# Hazardous Waste Ground-Water Task Force

Evaluation of  
Uniform Tubes, Inc.  
Collegeville, Pennsylvania

### UPDATE OF THE HAZARDOUS WASTE GROUND-WATER TASK FORCE

GROUND-WATER MONITORING EVALUATION

Figure 10  
Interim Status Monitoring Wells  
June 1985

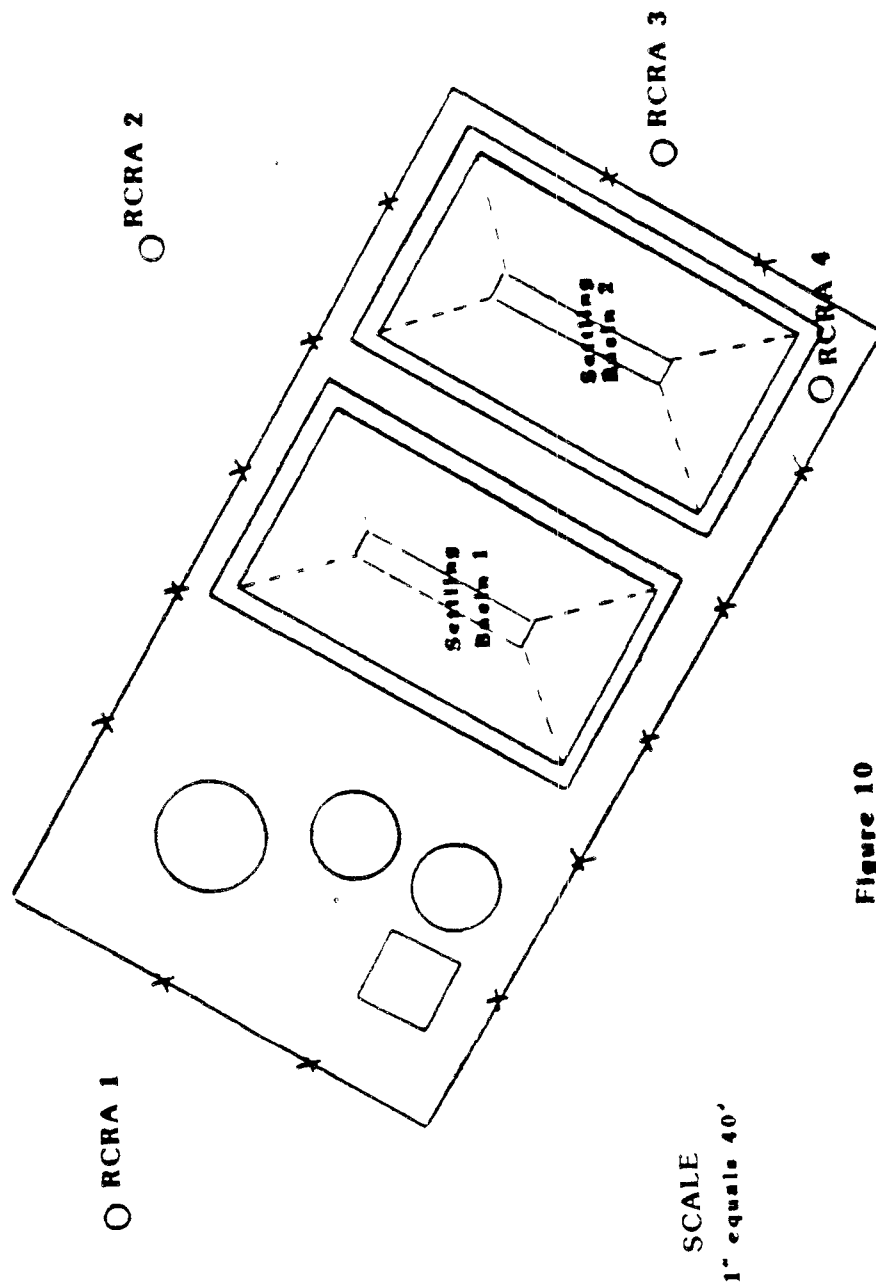
of grout. The purpose of the grout is to seal the annular space. Unless an excess of grout is used, as would be indicated by a surface return, the adequacy of the seal is questionable and surface water may enter the well. The concrete aprons around the wellheads, which are supposed to drain surface water away, were broken at all four wells.

The vertical locations of the well screens are also questionable because they are probably not monitoring the same aquifer zones (see Site Hydrogeology section). As a result, the water level data are not comparable for the purpose of determining flow directions and satisfying the requirements for
